Product Change Notification - SYST-07AFZV254

ERRATA - SAM D11 Series Family Silicon Errata and Data Sheet Clarifications

SAM D11 Series Family Silicon Errata and Data Sheet Clarification

FIGURE 35-3: BOD33 HYSTERESIS OFF

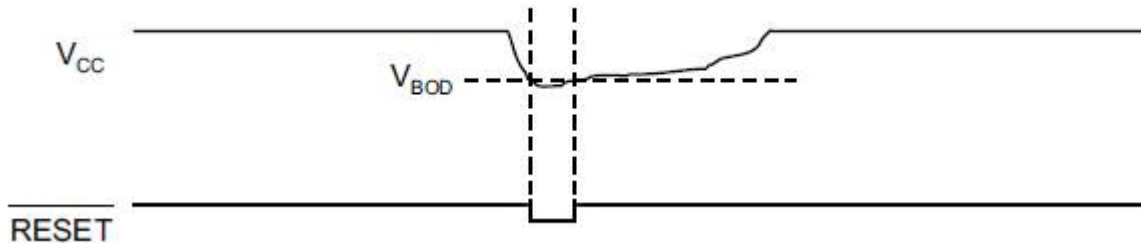
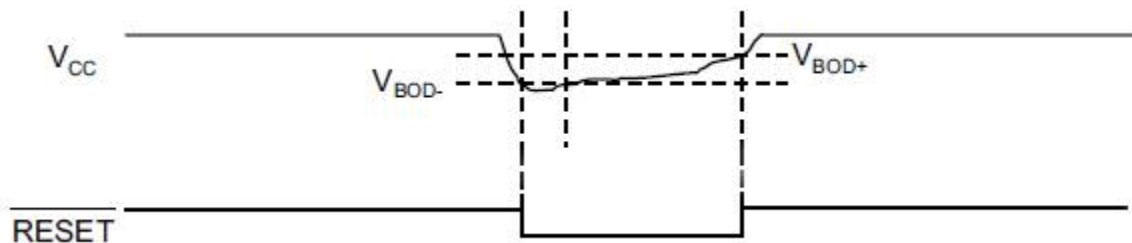
4. Module: Brown Out Detectors Characteristics

Figures 35-3 and 35-4 have an incorrect reset Polarity value. The correct figures are displayed as follows:
